Office Action Summary	Application No. 10/534,178	Applicant(s) BECK, JOSEF	
	Examiner DNYANESH KASTURE	Art Unit 4147

DETAILED ACTION

FIG. 1B

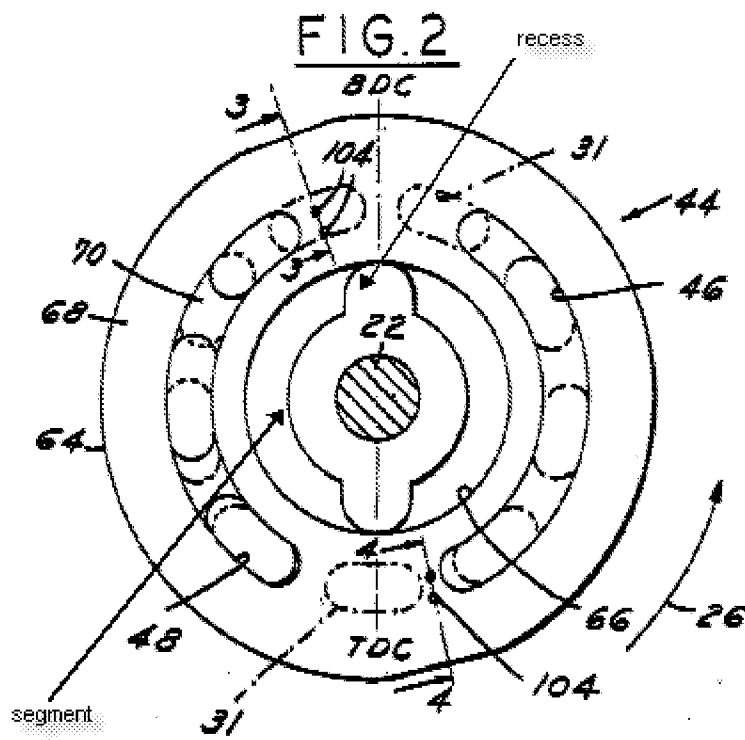
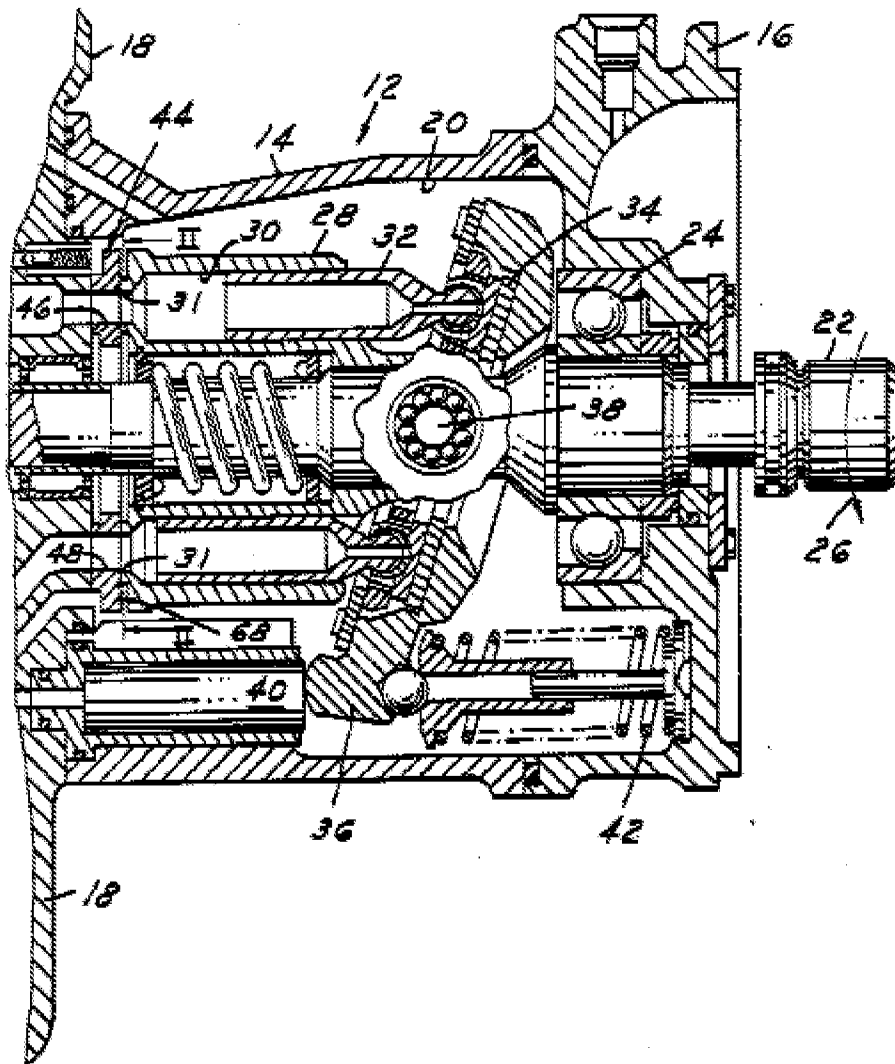
5. In Re claim 1, with reference to figures 1B and 2 depicted above, Tovey discloses a control plate (44) for an axial piston machine (12) having at least two control openings (46), (48) by means of which cylinder bores (30) of a cylinder drum (28) rotatably mounted (on shaft (22)) in housing (14) are alternately connected, on rotation

of the cylinder drum (28), to a high pressure connection (48) and a low pressure connection (46) a through opening (66) formed in the control plate wherein:

- the radially inner edge (depicted by label 66 pointer) of the control plate (44) is designed as a centering surface around shaft (22)
- the centering surface comprising plurality (2) of partial surfaces formed on segments (depicted above in Figure 2) of the inner edge of the control plate (44) which extend radially inward into the through opening (66) as depicted in Figure 2, and are separated by recesses as depicted

6. In Re claim 3, Figure 2 of Tovey depicts the thickness of the segments is substantially the same as the depth of the recesses, and they also have a finite width. The recess transforms into a gap between the shaft (22) and the radially inner edge (depicted by label 66 pointer) after assembly of the machine.

7. In Re claim 4 and 12, Figure 1B of Tovey depicts a radial edge (lip that is pointed to by the arrow associated with label (44)). The lip surrounds the plate around the outer edge and therefore is connected to the high-pressure connection and the low-pressure connection in the region of all the control openings.

8. In Re claim 6, Figure 2 of Tovey depicts the thickness of the segment is less than the thickness of majority of the plate.

9. In Re claim 8, with reference to figures 1B and 2 depicted above, Tovey discloses an axial piston machine (12) having a cylinder drum (28) which is rotatably mounted in a housing (14) and in which are made cylinder bores (30) in which pistons (32) are axially displaceably arranged, the cylinder bores (30) having openings (31) towards and end side of the cylinder drum (28) are alternately in connection with a high-pressure connection (48) and a low-pressure connection (46) via at least two control openings (46), (48) of a control plate (44), the control plate (44) having through opening (66) wherein:

- the radially inner edge (depicted by label 66 pointer) of the control plate (44) is designed as a centering surface around shaft (22)
- the centering surface comprising plurality (2) of partial surfaces formed on segments (depicted above in Figure 2) of the inner edge of the control plate (44) which extend radially inward into the through opening (66) as depicted in Figure 2, and are separated by recesses as depicted

11. In Re claim 11, the radial extend of the recess is greater than the radial extend of the segment as depicted in Figure 2 of Tovey.
